**MRP Materials Reliability Program** \_\_\_\_\_ **MRP 2014-031**

Subject: Transmittal of the additional RAI responses to the NRC relating to WCAP-17096-NP, Revision 2 "Reactor Internals Acceptance Criteria Methodology and Data Requirements" (TAC NO. ME4200) PA-MS-0473R5.

Subject: Pressurized Water Reactor Owners Group  
**Additional RAI Response (LTR-RIAM-14-94, Rev 1) to the NRC Request for Additional Information (RAI) on PWR Owners Group (PWROG) WCAP-17096-NP, Revision 2 "Reactor Internals Acceptance Criteria Methodology and Data Requirements" (TAC NO. ME4200) PA-MS-C-0473R5**

**Update for  
WCAP-17096-NP, Section W-ID: 2  
Control Rod Guide Tube Assembly Lower Flange Welds**

**W-ID: 2                      Control Rod Guide Tube Assembly**  
**Lower Flange Welds**

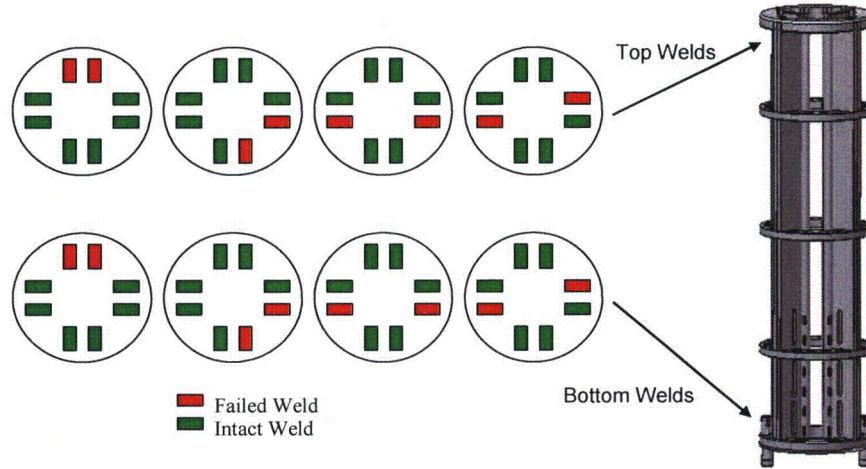
This letter provides additional information relative to WCAP-17096-NP, Section W-ID: 2, Control Rod Guide Tube Assembly Lower Flange Welds (Enclosure 1).

Attachment A contains the update for WCAP-17096-NP, Section W-ID: 2, Control Rod Guide Tube Assembly Lower Flange Welds [1]. Attachment A incorporates the Request for Additional Information (RAI) responses from RAI 26 in OG-12-202 [2] and RAI F in OG-12-519 [3]. The RAI response is part of the scope under Pressurized Water Reactor Owners Group (PWROG) project authorization PA-MS-0473 [4].

Method:	Enhanced visual (EVT-1) examination to determine the presence of crack-like surface flaws in flange welds no later than 2 refueling outages from the beginning of the license renewal period and subsequent examination on a 10-year interval.
Coverage:	100% of outer (accessible) CRGT lower flange weld surfaces and adjacent base metal as prescribed in the latest approved version of MRP-227. See MRP-227-A Figure 4-21.  The intent of the CRGT lower flange weld inspection is to provide a reasonable sample size for monitoring cracking degradation in the flange welds. The size of the sample is determined by the coverage requirements established in MRP-227-A. The adequacy of the sample size may be evaluated using the statistical analysis techniques described in NUREG-1475, Revision 1.
Observable Effect:	Any individual weld with observed crack must be assumed to have failed. The vertical beam portion appears to be out of position.

Failure Mechanism:	Flow in the upper head applies bending moment to control rod guide tube assembly. Maximum bending stresses tend to occur near top of continuous guidance section. Stresses may lead to formation of SCC or fatigue cracks. Weld cracking may lead to loss of stiffness in guide tube assembly and loss of support capability.
Failure Effect:	Loss of structural stability. Excessive deflection could impede control rod assembly insertion.
Failure Criteria:	Design limits on the CRGT assembly are generally expressed as a maximum allowable load, which is determined based on the assembly compliance. This analysis implies a maximum allowable deflection. Interference between the guide cards and the guide tubes occur when the deflection exceeds this limit.
